**MARION TOWNSHIP PLANNING COMMISSION  
AGENDA**

Re: **TAMARACK PLACE**  
Final Site Plan resubmittal

RE: Tamarack Place – Phase 3  
Updated Final Site Plan Review

# Final Site Plan Review for Marion Township Planning Commission

**SITE PLAN NW**

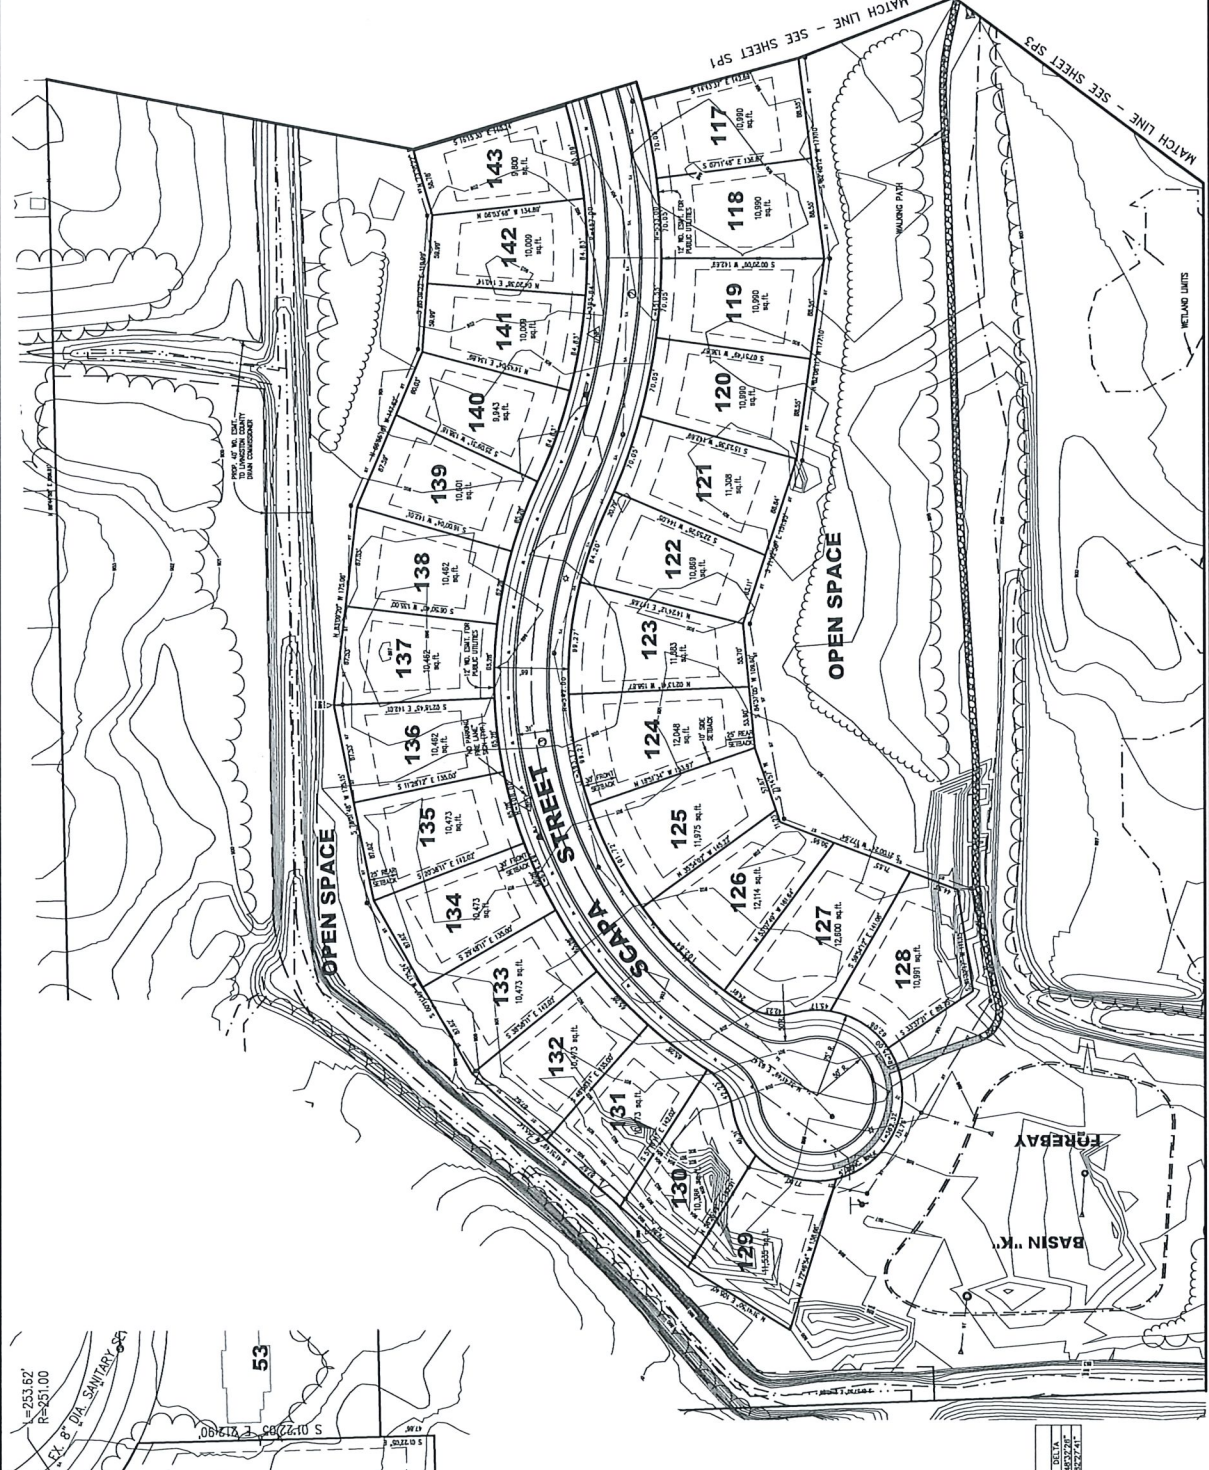
- Tax ID numbers for each unit have been depicted on sheet AE.
- Zoning district designation has been corrected on sheet DP
- Demolition has been updated to reflect current conditions on sheet EX
- Tree protection fencing has been depicted on sheet EX
- Proposed Ash and Austrian Pine tree species have been replaced with Silver Linden and Concolor Fir tree species
- Proposed street light cut sheet and detail have been revised to LED on sheet LS2
- The ultimate drainage outlet has been identified on sheet WS
- Notes identifying road and drainage system ownership, and speed limit has been added to the Cover sheet
- Minor corrections to detention basin calculations have been completed in accordance with comments provided in the approval letter prepared by LCDC dated July 10, 2024

UTILITY PLAN SE

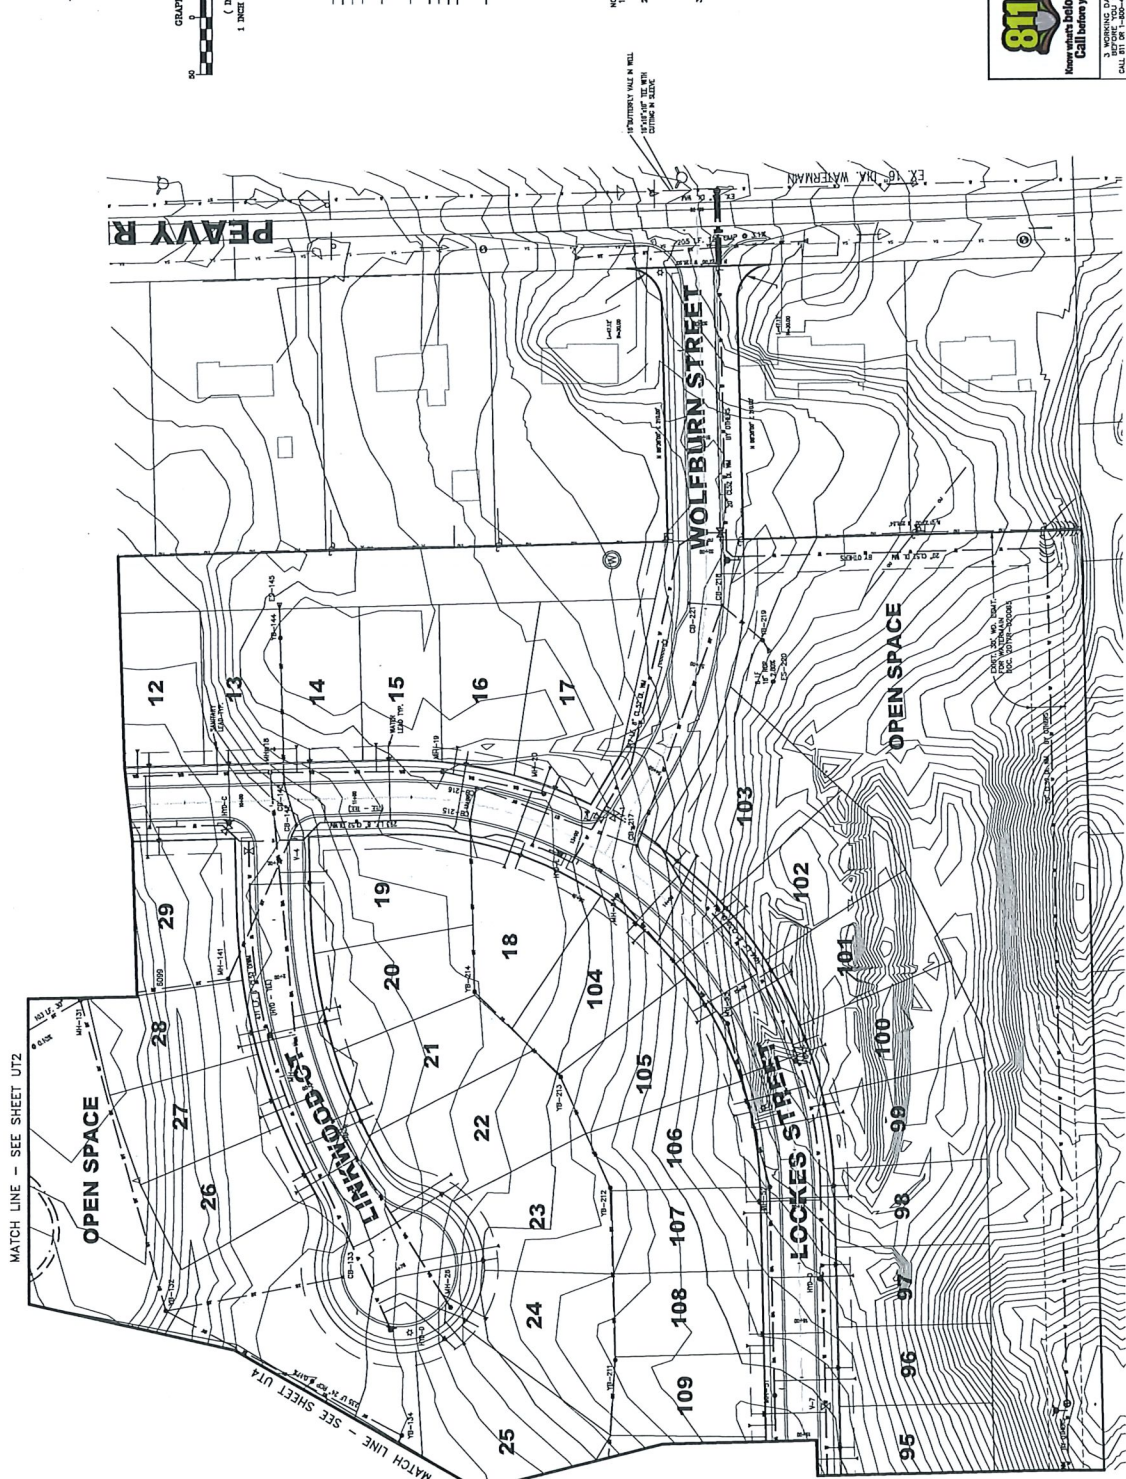
MHOG will be constructing the 20" diameter water transmission pipe within their existing easement along the Southerly development boundary, from Pinckney Road to the Westerly boundary of Tamarack Place. This allows water main along Wolfburn Street, the Southerly portion of Lockes Street and the Southerly portion of Dalmore Street, to be revised to 8" diameter pipe. The modified water main is depicted on utility plan sheets UT3 and UT4.

**BASIN N CONTROL STRUCTURE CALCULATIONS**

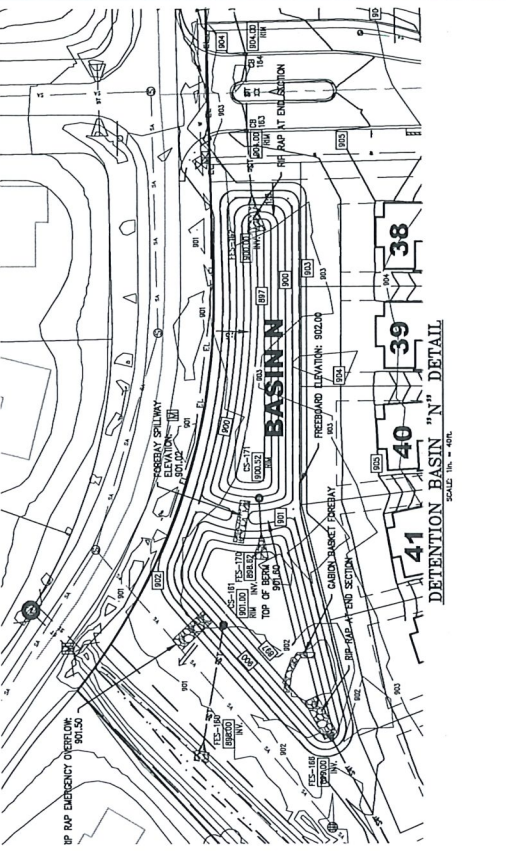
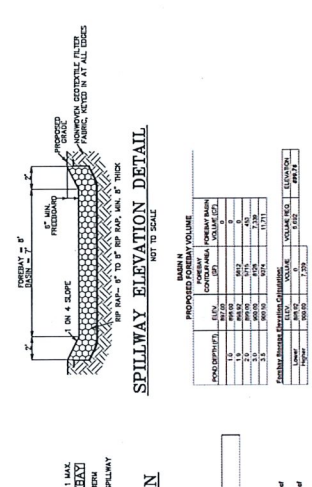
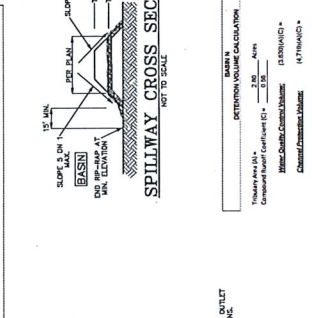
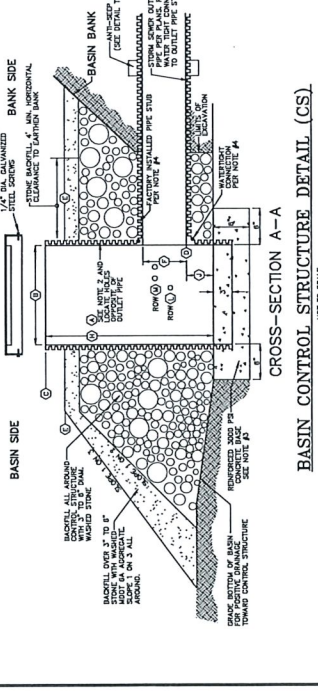
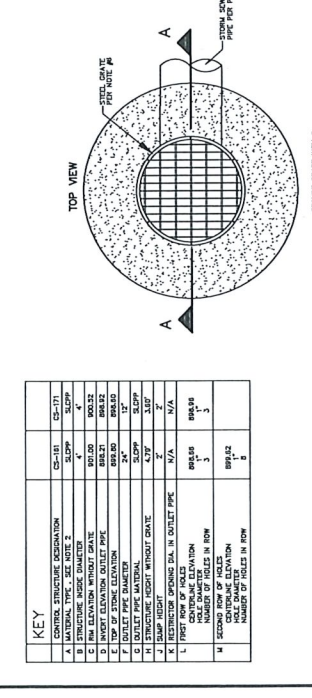
Detention Basin N has been revised to conform with the current Livingston County Procedures and Design Criteria for Stormwater Management Systems as required by the Drain Commissioner. The groundwater elevation at SB-1, as depicted on the boring log, is at an elevation of 899.2. SB-1 is located approximately 400 feet upgradient from the detention basin, and approximately 520 feet from the county drain. The groundwater gradient through the existing sandy soils will be generally consistent between SB-1 and the existing drain, resulting in a groundwater elevation in the vicinity of the detention basin below the low water elevation of the proposed basin. The stormwater management system has been approved by the Livingston County Drain Commissioner.

1. Plans should be reviewed and approved by:
  - a. Fire Marshal
  - b. Township Planner
  - c. Livingston County Drain Commissioner
  - d. Livingston County Road Commission
2. Basin N should be designed so that the groundwater does not affect the storage of the basins.
3. A note should be added somewhere in the plans indicating the ultimate outlet for stormwater runoff.
4. Typical detail and illumination pattern for the proposed exterior lighting is required.
